**Notice of Allowability**

10/669,999

HARNEY, DONALD

Fig. 5

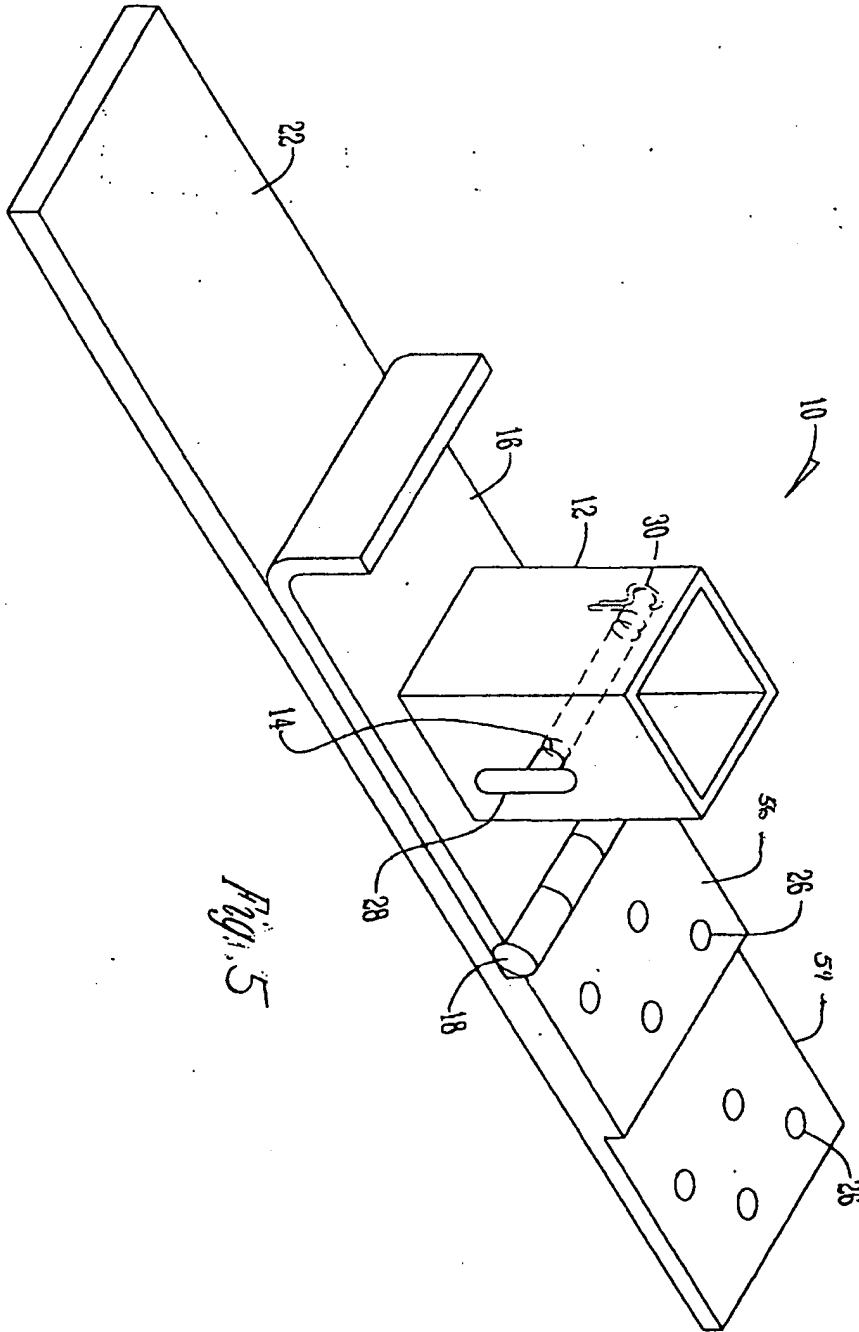
The following changes to the drawings have been approved by the examiner and agreed upon by applicant: Applicant must amend the drawings to reflect the sleeve received "onto", i.e., about the sleeve. Also, newly submitted Figure 5 must be labeled as "new", so as to properly be entered. In order to avoid abandonment of the application, applicant must make these above agreed upon drawing changes.
